**Consulting Service for the Supervision of Works for the George Price Highway Rehabilitation Project
Design Review Report Addendum – Lot 3 BoQ Review**

7.3 Section III (Lot 3) Review of Quantities

IDB Project LO-3344/OC-BL: GEORGE PRICE HIGHWAY REHABILITATION PROJECT
Government of Belize – Ministry of Works – PEU

Design Review Report February 2018

Figure 3.1 Location of bridges and catchment areas

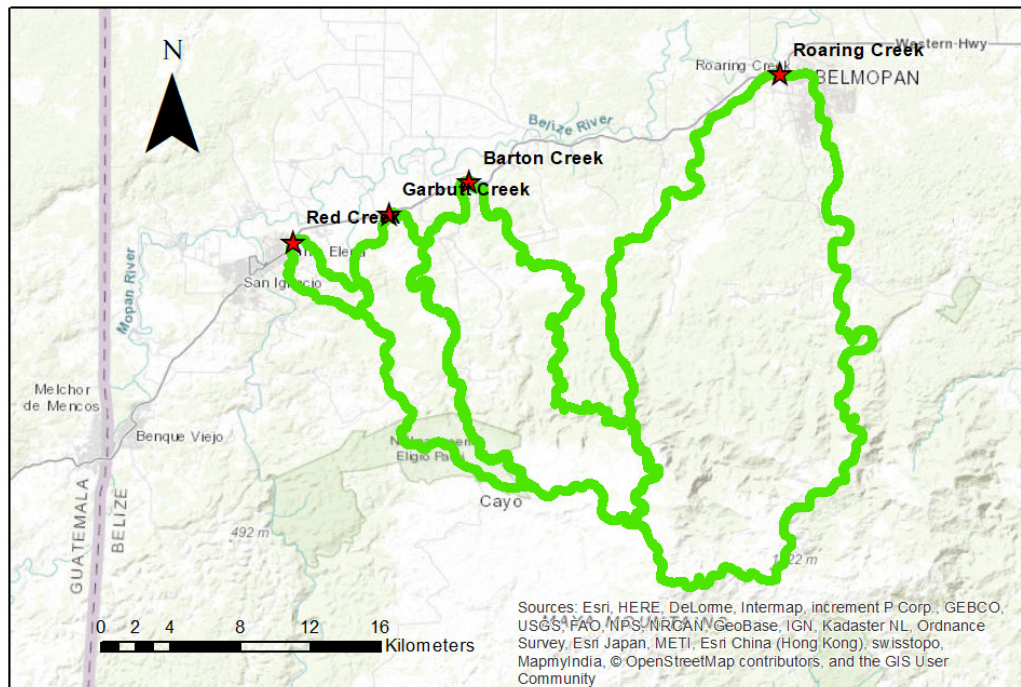
Figure 3.1). The design studies questioned the catchment area used for the Red Creek crossing but did not present an alternative. It will clearly be necessary to re-assess the design discharge for the Red Creek crossing.

Figure 3.1). The feasibility level hydrological assessments of both the Red Creek and Garbutts Creek crossings is therefore very questionable and revised flood estimates at these sites should be undertaken.

Figure 3.5 Required roadside drain discharge capacity

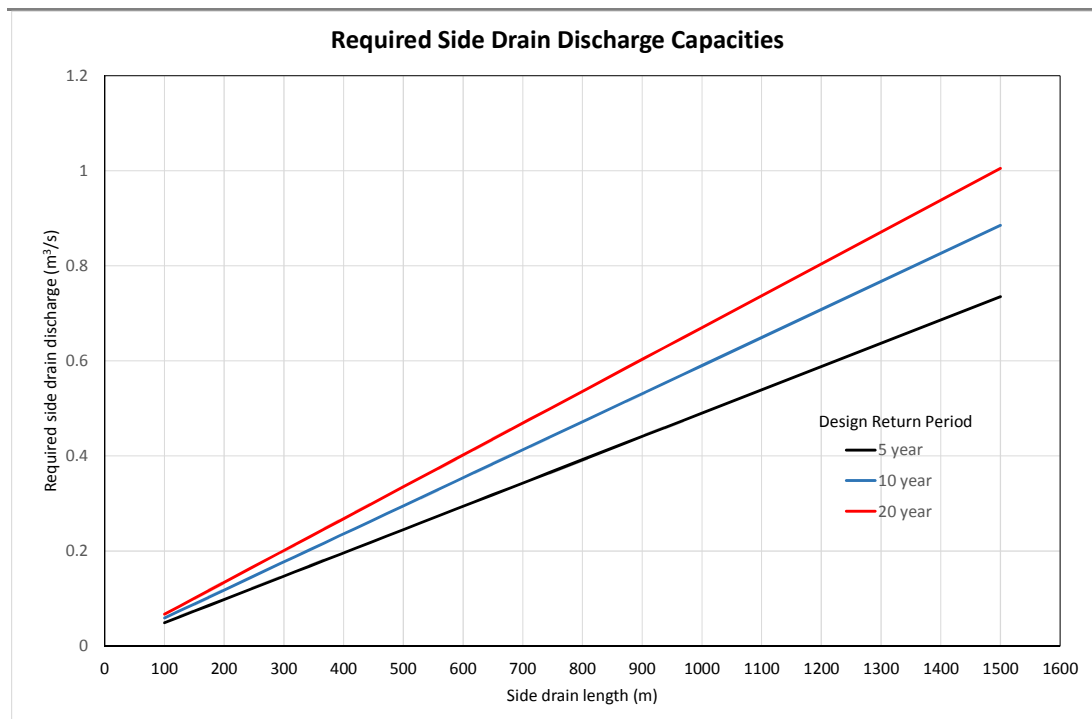
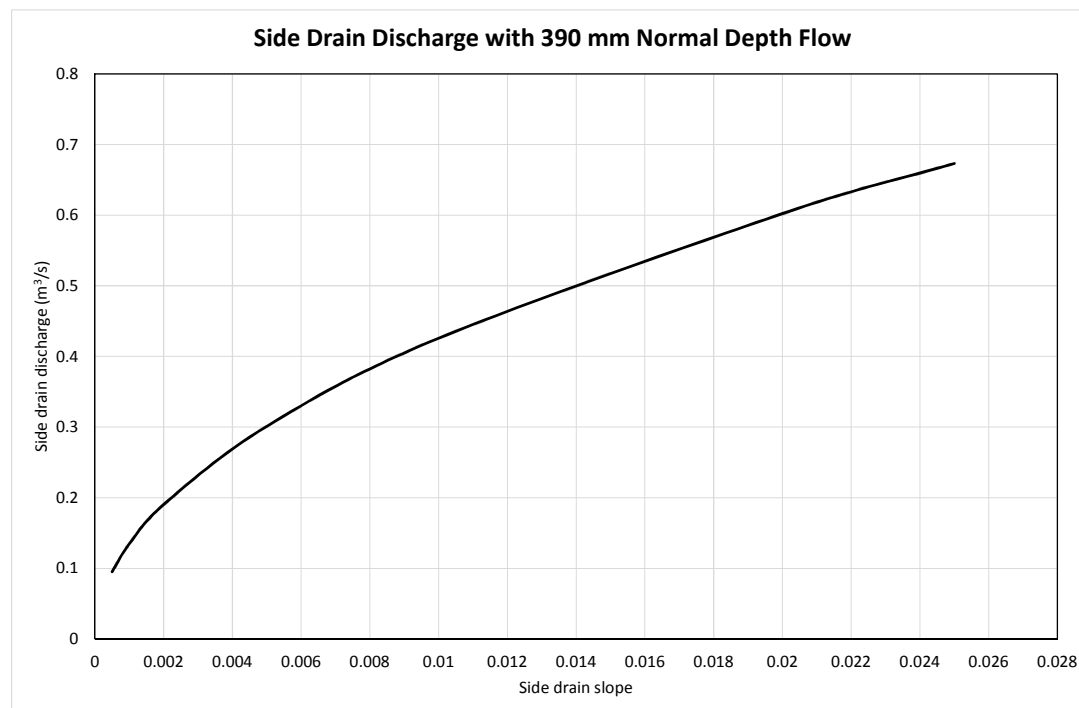
The analysis undertaken indicates that the roadside drain on the western reach between culverts 203 and 204 is undersized, as is the roadside drain on the western reach between culverts 209 and 210 for a 20 year return period, and the roadside drain on the eastern reach between culverts 321 and 322.

Figure 3.7 Plot of culvert areas against catchment areas

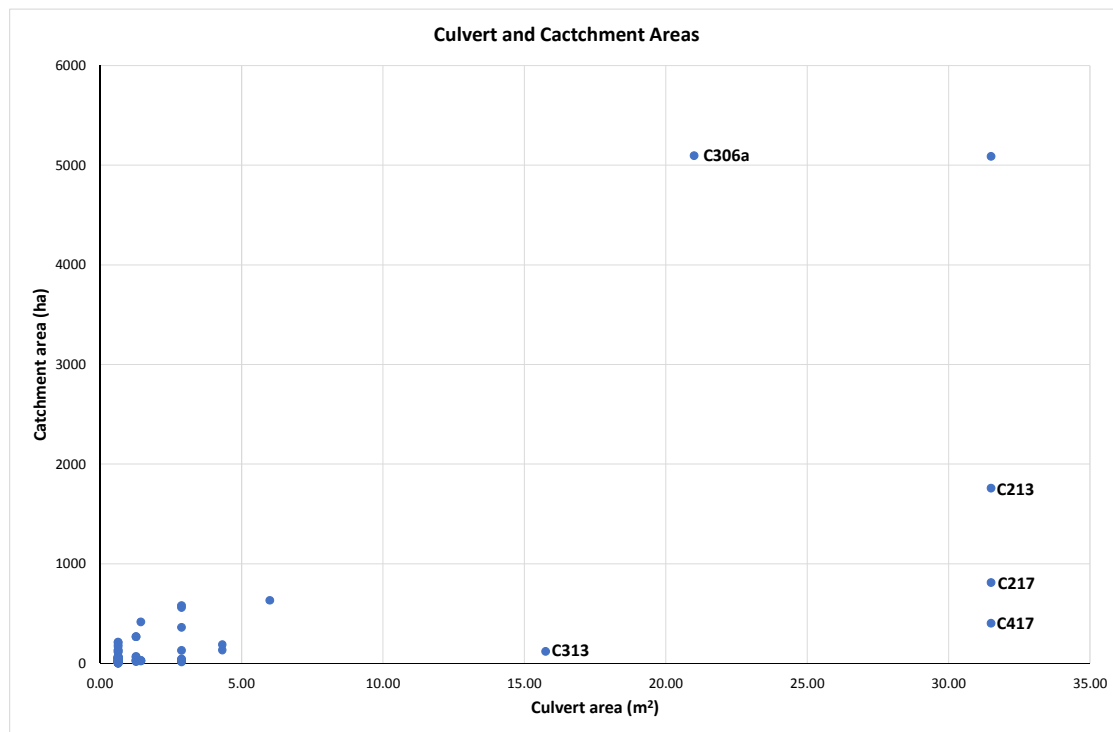
A site visit by the team leader and Client raised questions over the recommended sizing of replacement culverts C213, C217 and C306a. As part of the current review, no hydrological or hydraulic analysis has been carried out, but culverts cross sectional areas have been plotted against their catchment areas. Catchment areas were estimated from the SRTM90 DEM using ArcHYDRO tools. For large catchments the areas estimated will be reliable, but for micro-catchments they will not be. Figure 3.7 presents the plot of culvert areas against estimated catchment area. It would appear that C213, C217, C417 and C313 may be over-sized. C306a does not appear to be over-sized.

It is recommended that the designs of C213, C217, C313 and C417 be revised. In order to do this channel cross sectional survey will have to be undertaken and ideally revised design storm rainfall data.
